# PROCUREMENT OF CONSULTING SERVICES FOR THE DETAILED ARCHITECTURAL AND ENGINEERING DESIGN (DAED) FOR NEW CLARK CITY (NCC) PROJECTS (REMAINING ROADS AND UTILITIES)

### Bid Bulletin No. 02

This Bid Bulletin clarifies queries/questions raised during the Pre-Bid Conference held on 20 October 2023 and written clarifications received through email pertaining to the above cited Consulting Services.

# "Map location of Airport to NCC Access Road and BSP West Road"

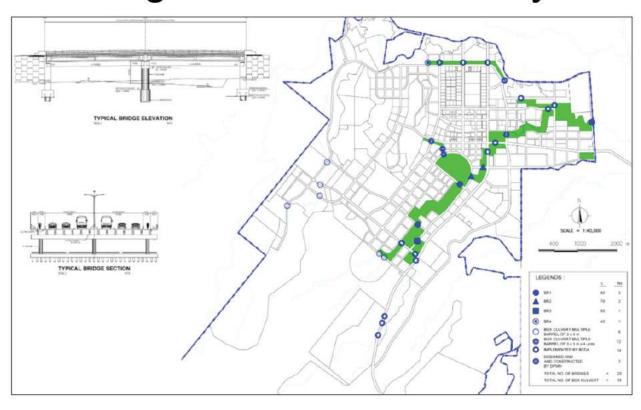
3. Relative to the design of the constructed roads including the Airport to NCC road and West Road and Utility Corridor of BSP Complex, can you provide us the lengths and limits	The length of the Airport-New Clark City Access Road is 20.00 km.  The West Road of Bangko Sentral ng Pilipinas is 0.70km.  The roads shall be subjected to actual site survey to determine the exact lengths and limits.  Please see map attached as "Annex A", the location of Airport to NCC Access
